**Review & Evaluation of FEMA's Coastal Flood Risk Study**  
Data and Documents Review Technical Memorandum (Deliverable 4.1)  
Task Order #1778-01

October 1, 2020 | 13134.201.R3.Rev0

**PALM BEACH COUNTY**  
*Discover the Palm Beaches...  
 the Best of Everything*

Figure 4.3: 1% SWEL – Palm Beach County (FEMA, 2018; [12]).

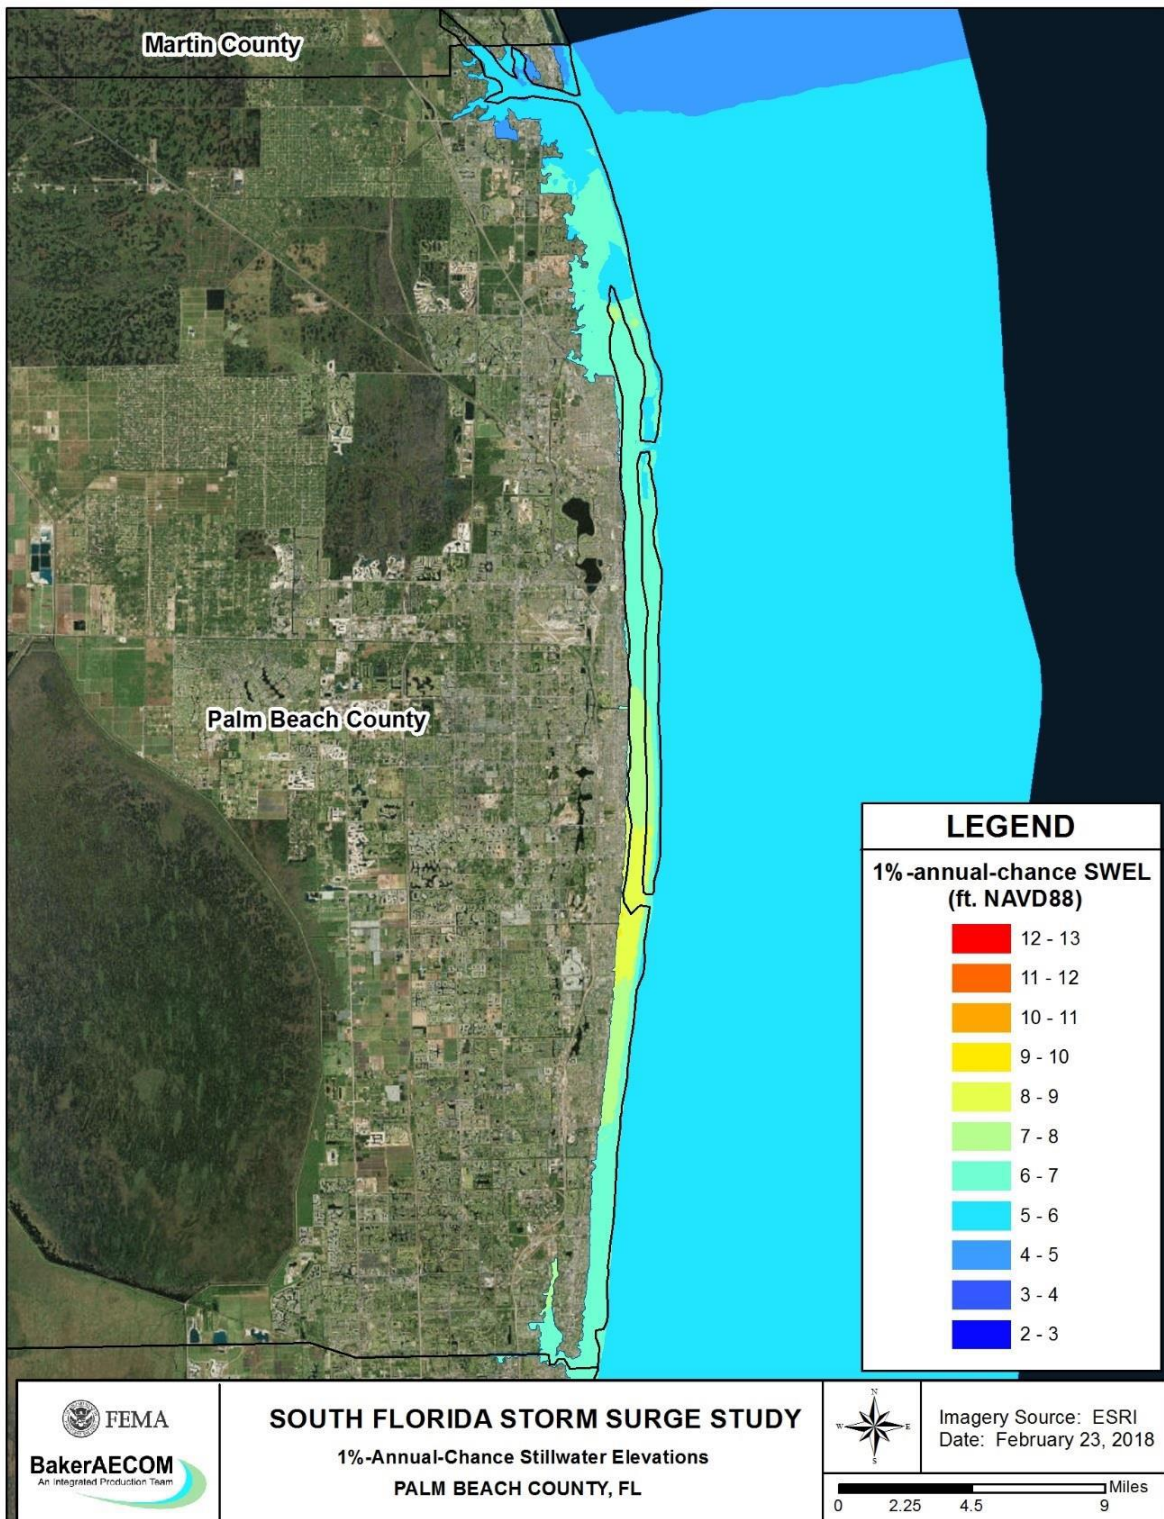
Based on initial review of 1% SWEL as reported by FEMA (Figure 4.3), the following locations within Palm Beach County were identified as areas that may warrant further consideration with respect to the developed model mesh. The buildup of water, and equally the exchange of water, may be the result of the coastal processes below, but FEMA’s model mesh will need to be reviewed in greater detail.

- Southern Lake Worth Lagoon: The highest 1% SWEL values were simulated within the southern portion of the Lake Worth Lagoon immediately interior of South Lake Worth Inlet (a.k.a. Boynton Inlet). This may be attributed to the exchange of water through the inlet, northerly winds (likely during landfalling hurricanes) forcing water within the lagoon south to the constriction of the ICW, or a combination thereof.

- Northern Lake Worth Lagoon: The next highest 1% SWEL values occur at the northern portion of the lagoon. Lake Worth Inlet (a.k.a. Palm Beach Inlet) is located further away as compared to the situation at the southern portion of the lagoon, but the inlet is wider and deeper improving its ability to exchange water with the Atlantic Ocean. Southerly winds (likely during exiting hurricanes and after the passing of landfalling hurricanes) forces water into the constricted ICW and tributary canals.

- Loxahatchee River: The river’s major tidal connection is through Jupiter Inlet, with some influence from the narrow ICW to the north and south. FEMA reported that the greatest discrepancy (ranging from 2.0 to 4.2 feet) between 1% SWELs for the SFL and ECCFL studies occurred within the river (see Section 4.4).

Figure 4.4: Redefined SFL and ECCFL Transition Area.

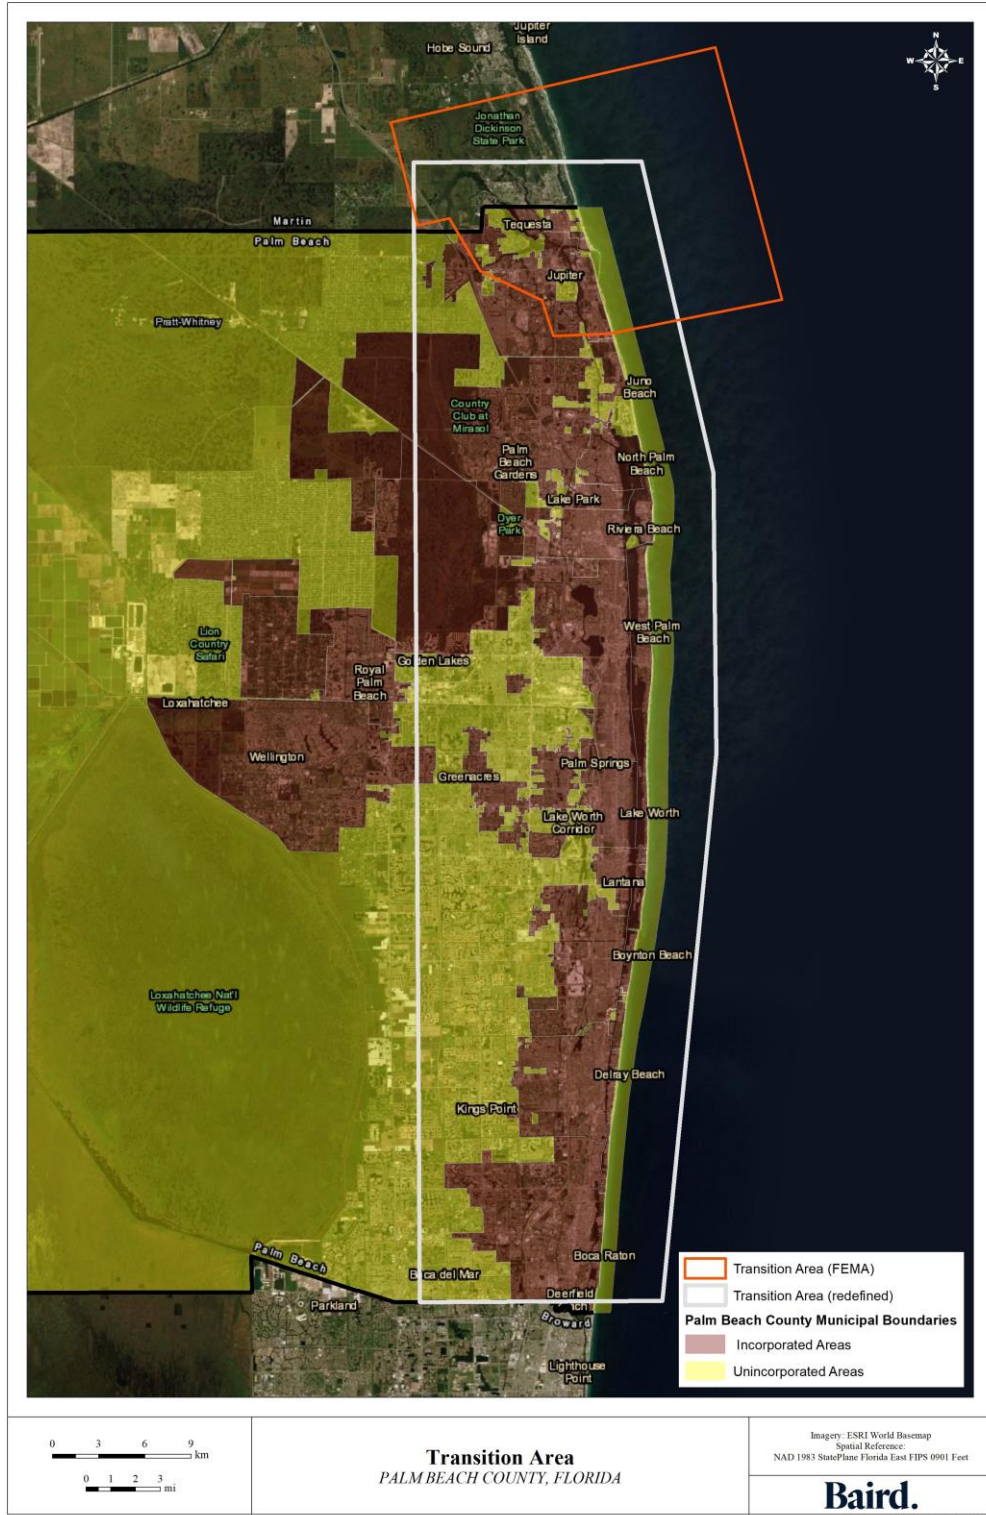
Justification for defining the 10-mile wide SFL study transition area was not provided by FEMA. The following presents a basis for redefining the transition area applied between the SFL and ECCFL studies that aligns with other FEMA studies.

- The differences at the study area boundary between the SFL and ECCFL studies were comparable on the open coast and 4 times larger within the Intracoastal Waterway (ICW) as compared to the differences reported at the northern boundary of the ECCFL study.

- The smaller adjustments at the northern boundary of the ECCFL were applied to the southern half (12 miles) of the 25-mile wide transition area. The transition area was defined to align with the limits of the Canaveral National Seashore.

- Assuming that the width of the SFL study transition area should be scaled to achieve a similar linear adjustment within the ICW as the ECCFL, the SFL transition area should have a redefined alongshore length of 48 miles, which is much greater than the 10-mile wide transition area used by FEMA. Assuming that the transition area is shifted south to align with the redefined adjustments applied within Palm Beach County as described below, the northern limit of the transition area would be approximately 3 miles north of the Palm Beach and extend south to include all of Palm Beach County (Figure 4.4).

- As such, there is a strong justification that at least 82% (40 miles) of the proposed redefined 48-mile transition area for the open coast and ICW be located within Palm Beach County. This redefined transition area would be located to include the entirety of Palm Beach County’s 45-mile coastline and extend 3 miles north into Martin County (Figure 4.4).

Figure 5.1: PFD - Transects 18, 33 and 86 South of Lake Worth Inlet (FEMA, 2019; [15]).

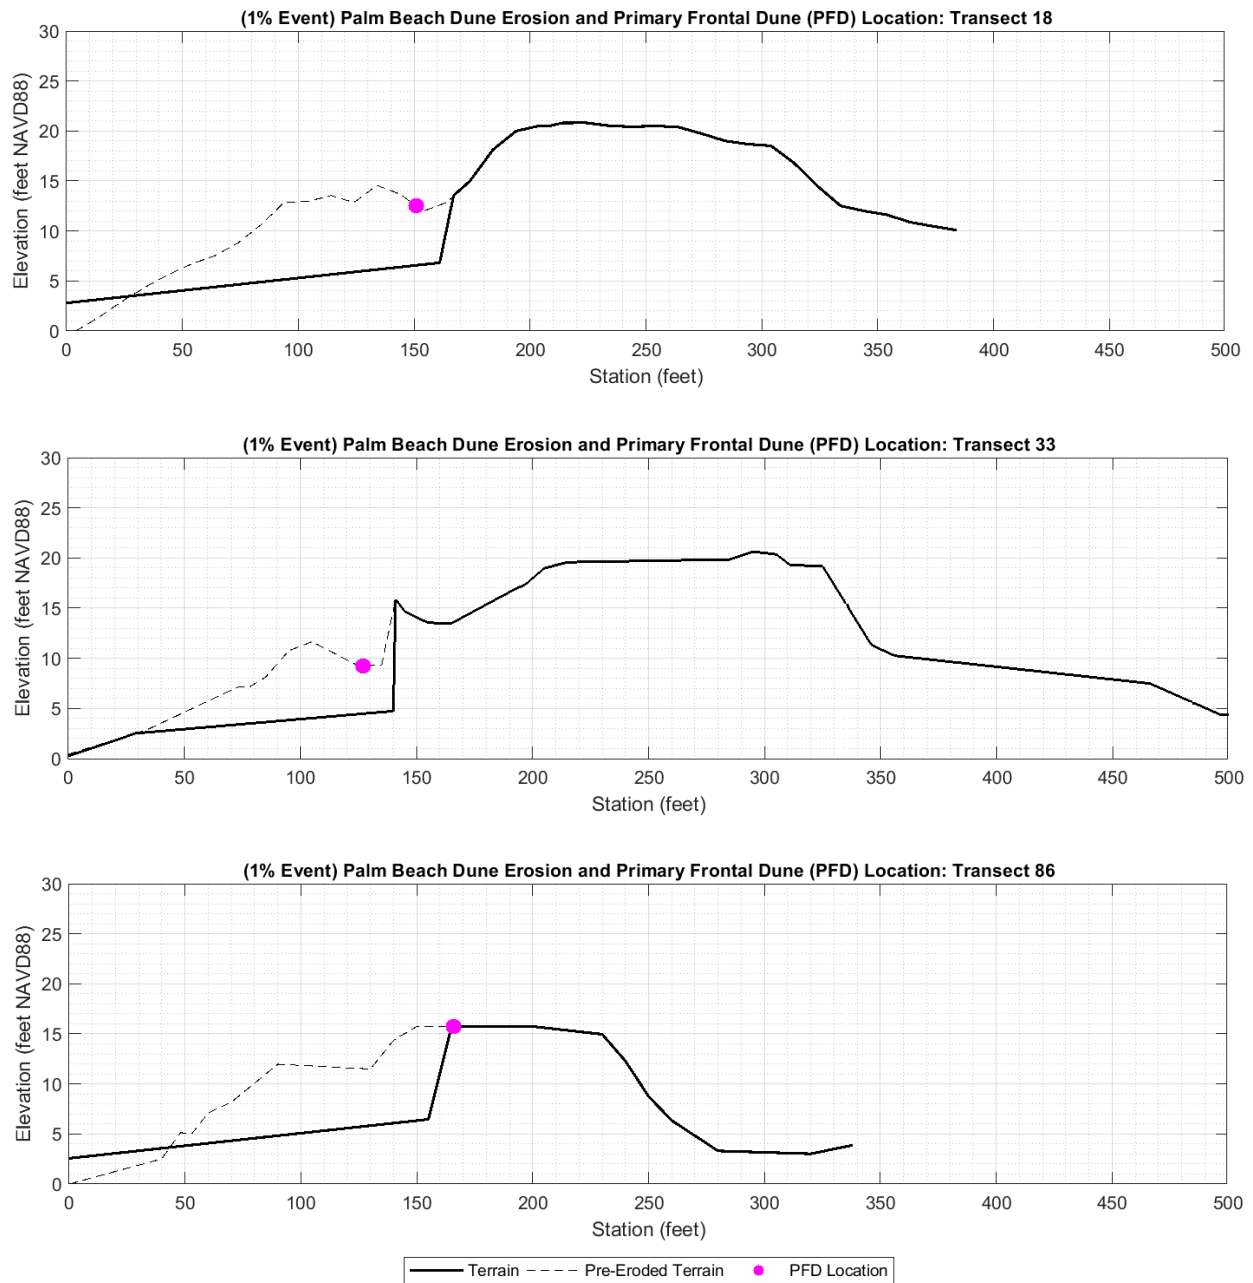
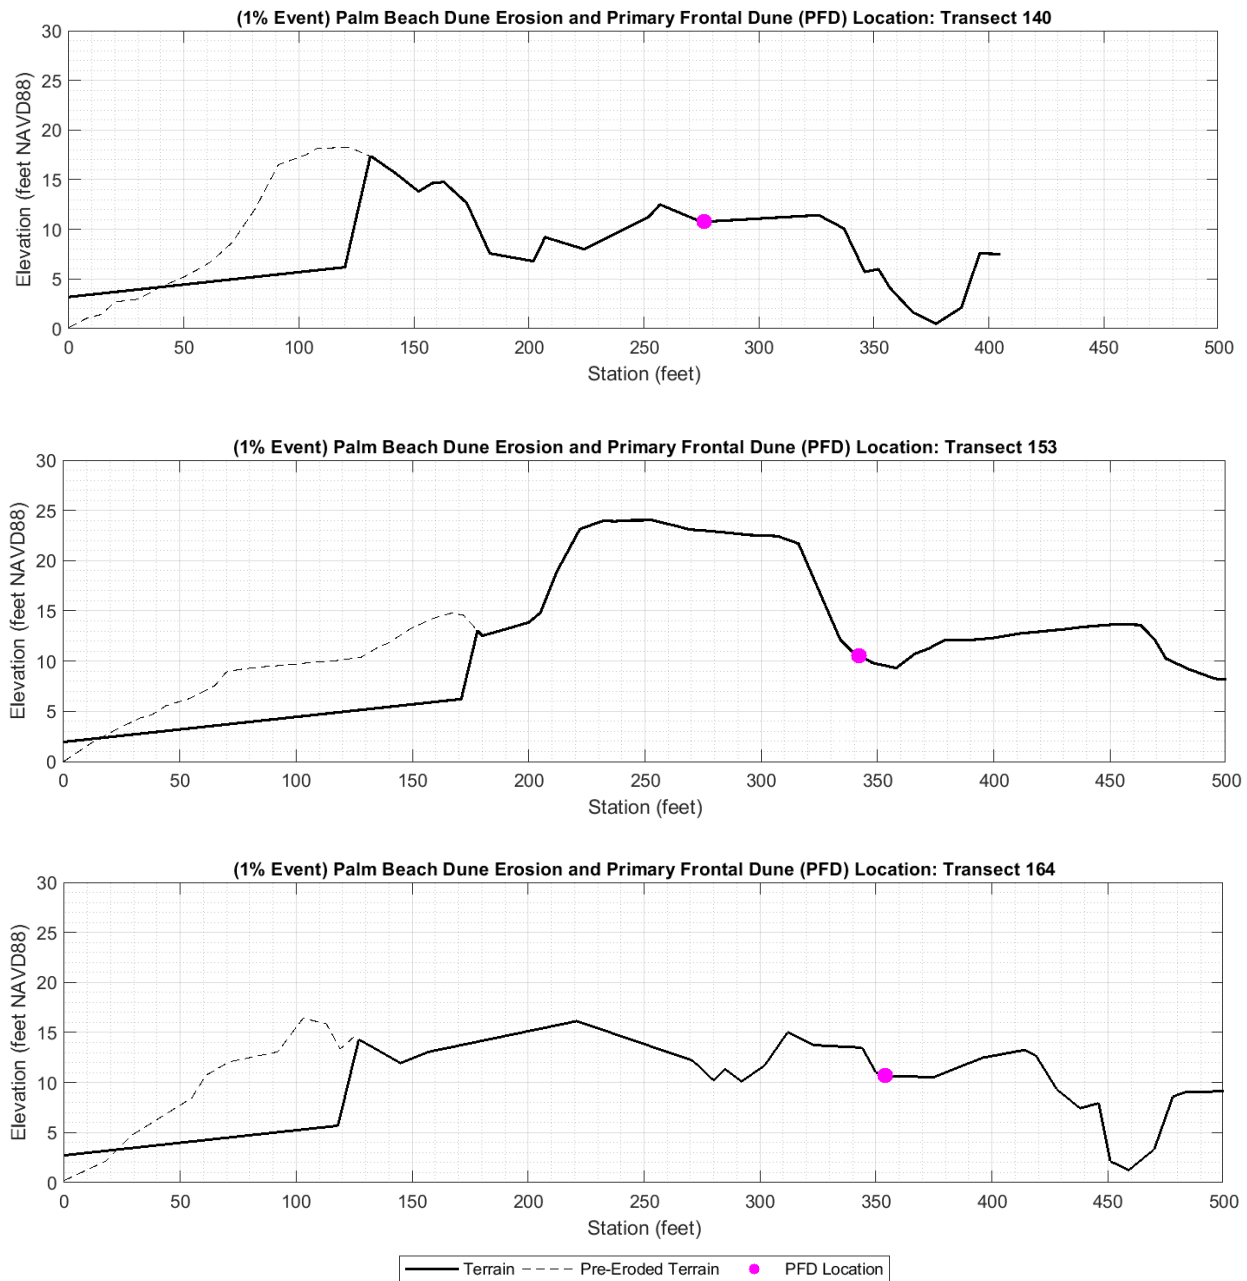
Example transects depicting the inconsistent PFD delineations south and north of the inlet are shown in Figure 5.1 and Figure 5.2, respectively. The pink dots in the figures represent FEMA’s PFD locations. The PFD locations are seaward of the highest portion of the beach profiles (15-20 feet, NAVD88) south of the inlet (Figure 5.1), while they are located landward of the beach profiles’ high point north of the inlet (Figure 5.2). Additional details regarding the open coast transects are provided in Appendix B.

Figure 5.4: Dune Removal – Transect 138 (FEMA, 2019; [15]).

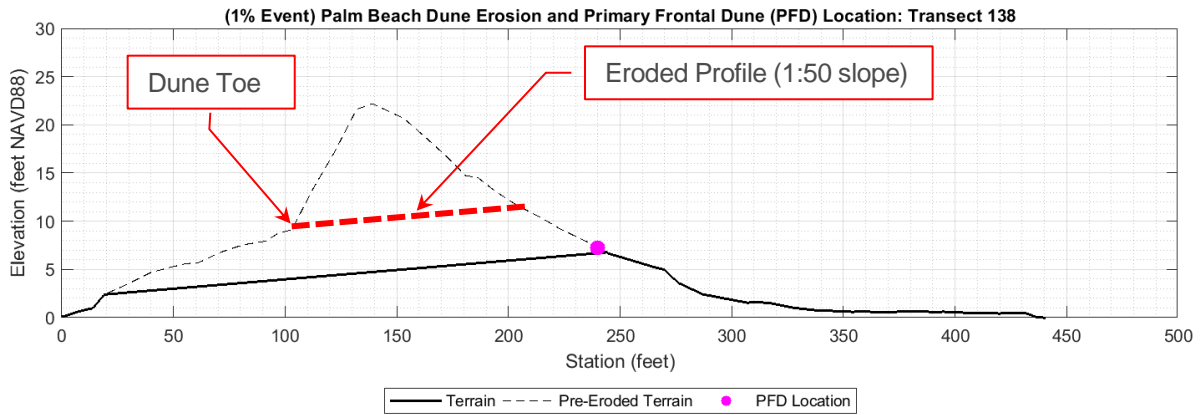
- **Transect 137 and 138:** FEMA identified dune removal for the transects and the slope of the eroded profile was specified according to the FEMA guidelines (Figure 5.4). Inspection of the profile suggests that a dune toe at a higher elevation (+9 feet, NAVD88) may be justified. A higher dune toe would raise the elevation of the eroded profile (depicted by the red dashed line, Figure 5.4) and reduce wave runup and overtopping across the dune. This is the only segment of coastline within the County that the landward limit VE Zone was mapped based on the breaking wave height and the VE Zone extended across the barrier island into the Lake Worth Lagoon (Figure 5.5). Breaking waves across the barrier island may have implications further inland as larger waves within the lagoon may result in increased base flood elevations and in modifications to the delineated "limit of moderate wave action" along the lagoon's interior shorelines.

Figure 5.6: PFD – Transect 147 (FEMA, 2019; [15]).

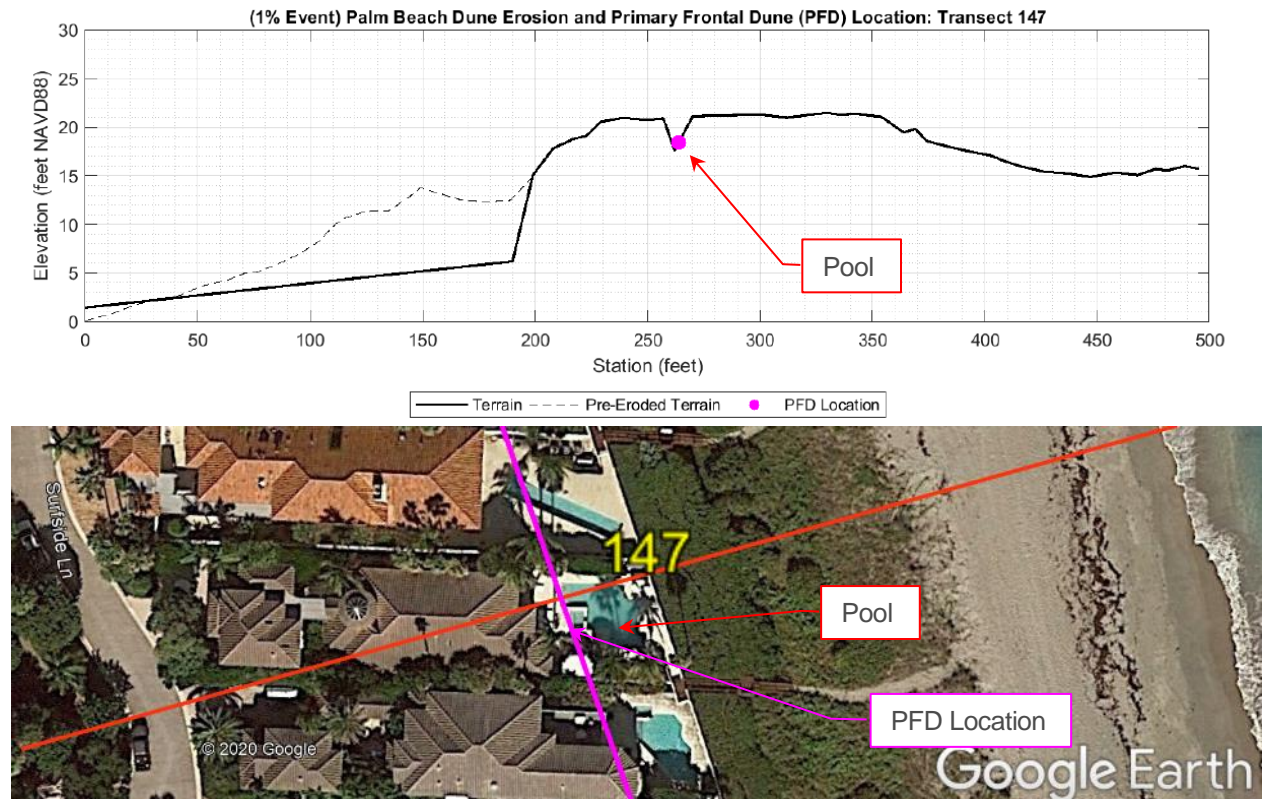
- **Transect 147:** The PFD was mapped within the pool of a single family residence (Figure 5.6). Revision to the PFD appears warranted to avoid this anomaly.
